1113 RIVERSIDE DR

CERTIFICATE OF COMPLETION/OPERATION PERMIT

Subject: 1113 Riverside Drive Mecklenburg County
File # : 8448A/577B
Parcel : 03115119 PO

Re: 1113 Riverside Drive
File: 8448-A
Parcel: 031-151-19

Date: Sept. 14, 1992

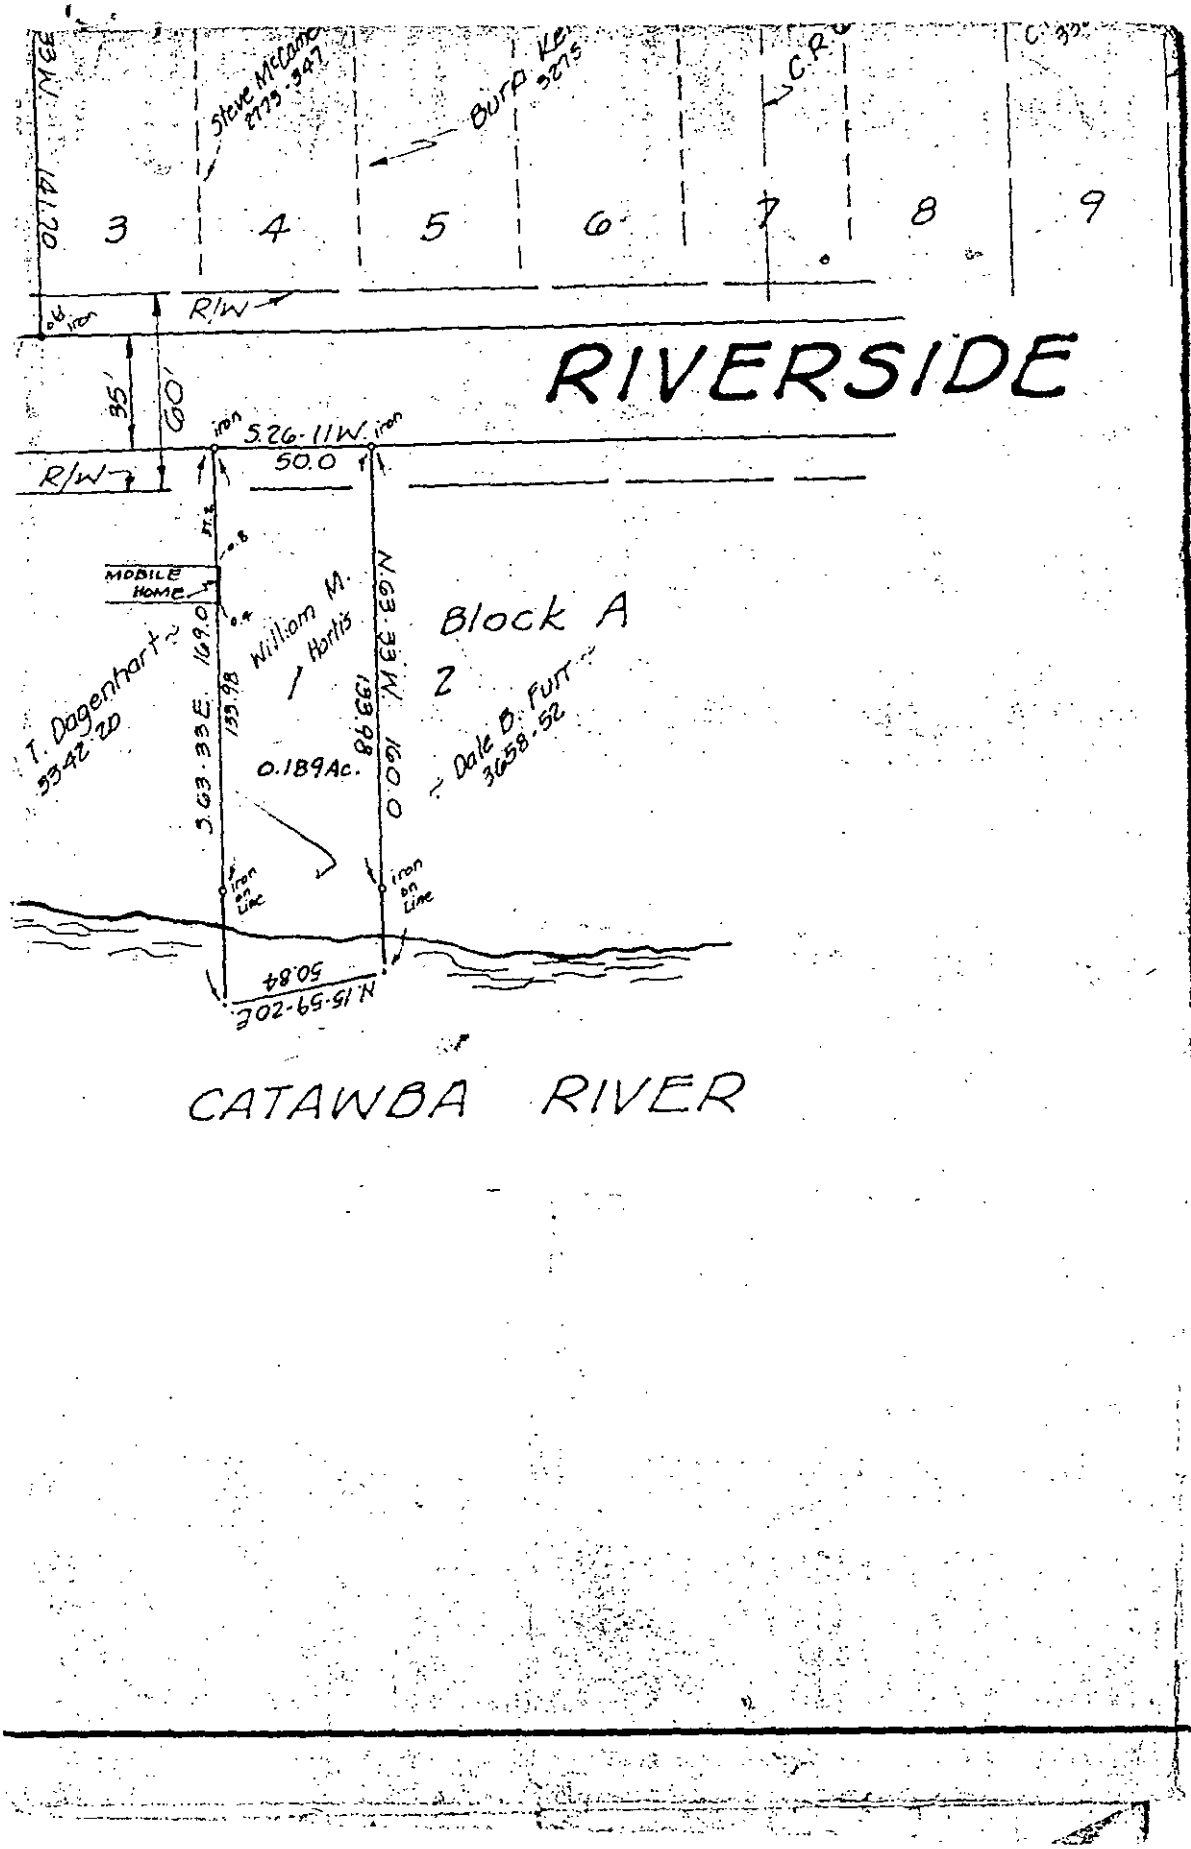
COMMENTS: System installed without permit - Approved PLAN on file used for installation Layout. Repair lines installed, not connected - Owner will install Bull-run Tyson 1" flow Divider and call for Approval

MECKLENBURG COUNTY
1113 RIVERSIDE DRIVE
FILE # 8448A
DATE: 9-9-92
SCALE: 1" = 20'

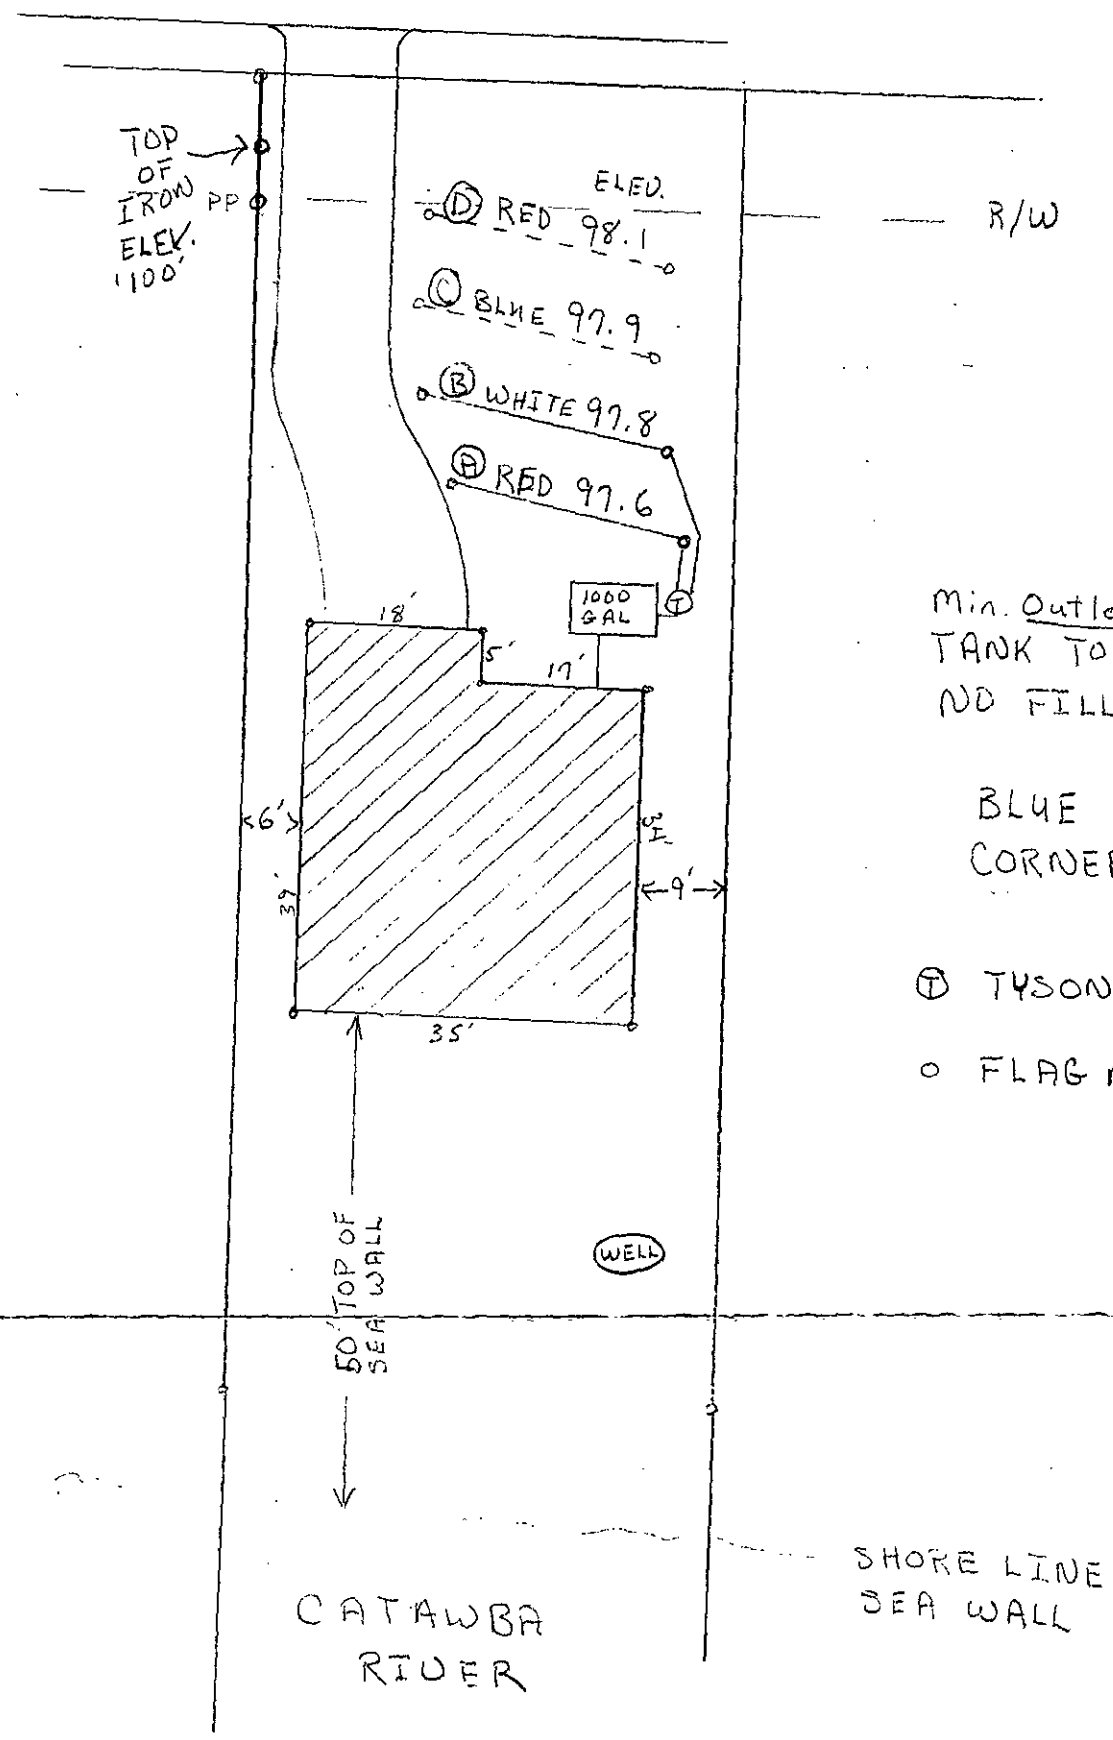
Your plans for the modified system for the above property as submitted are approved with the following comments:

-The well should be located 100 feet or no less than 50 feet away from any part of the sewage disposal system and repair area.

-Effectively rake and lime all trench sidewalls.

-Landscaping of repair area to be undisturbed. No grading, shaping, [illegible] anyway.
